HORIZON®. HRZ-D MANUAL
ADDENDUM
June 1980

ADDENDUM to: HRZ-D MANUAL, REVISION_1

JUNE 4, 1980

HORIZON CHASSIS/MOTHERBOARD MB-4	SHT
POWER SUPPLIES	5 of 5
© 1977, NORTH STAR COMPUTERS, INC.

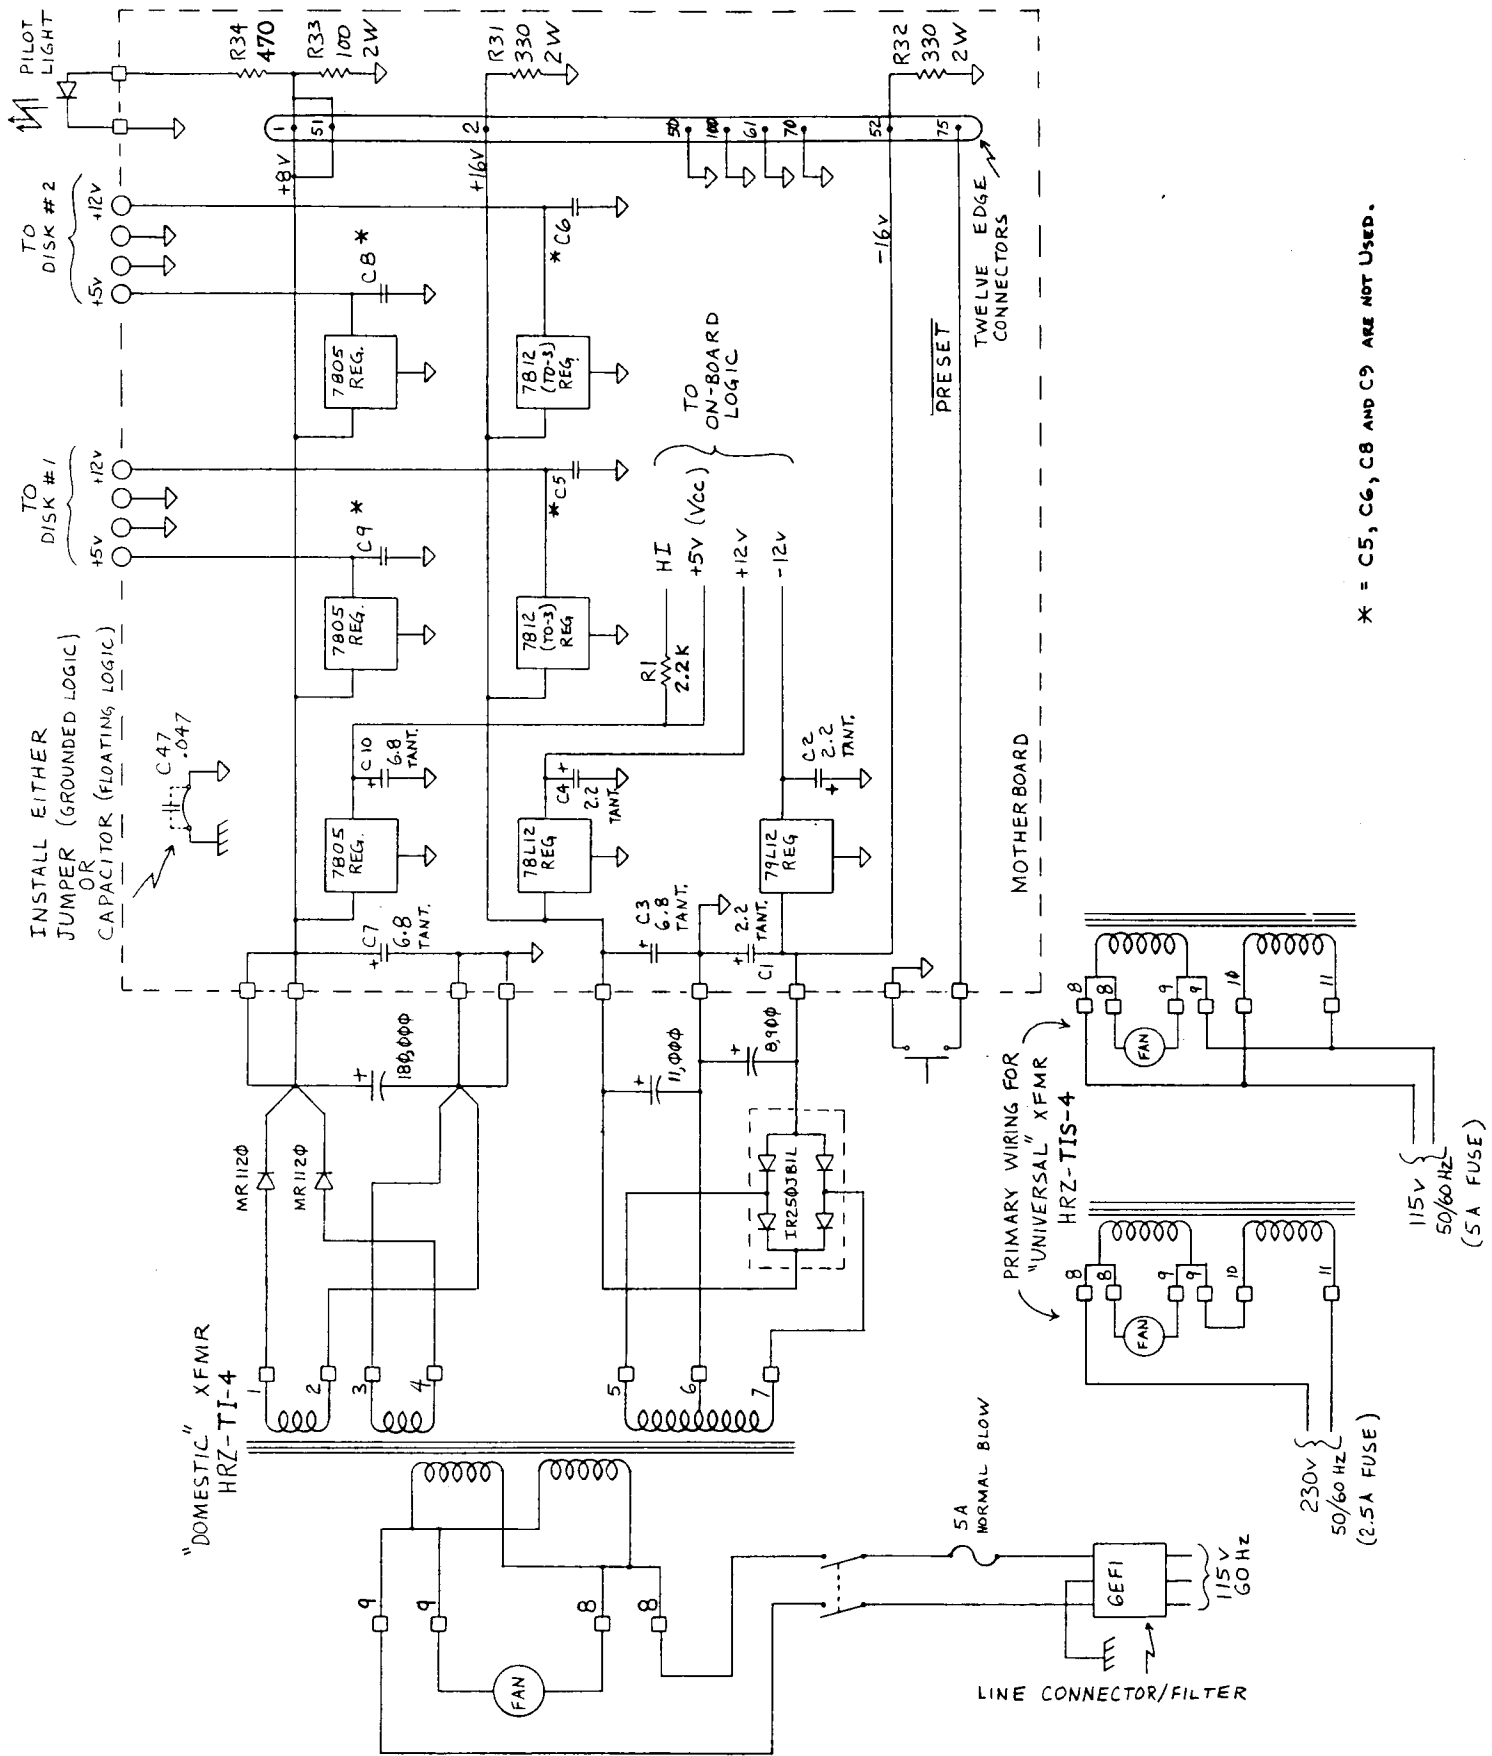
11) For all HORIZON Computer Systems containing motherboards marked "HRZ-MB-4", the following five pages of schematic drawings supersede pages 88, 89, 91, and 92 of the HORIZON Manual.

* = C5, C6, C8 AND C9 ARE NOT USED.
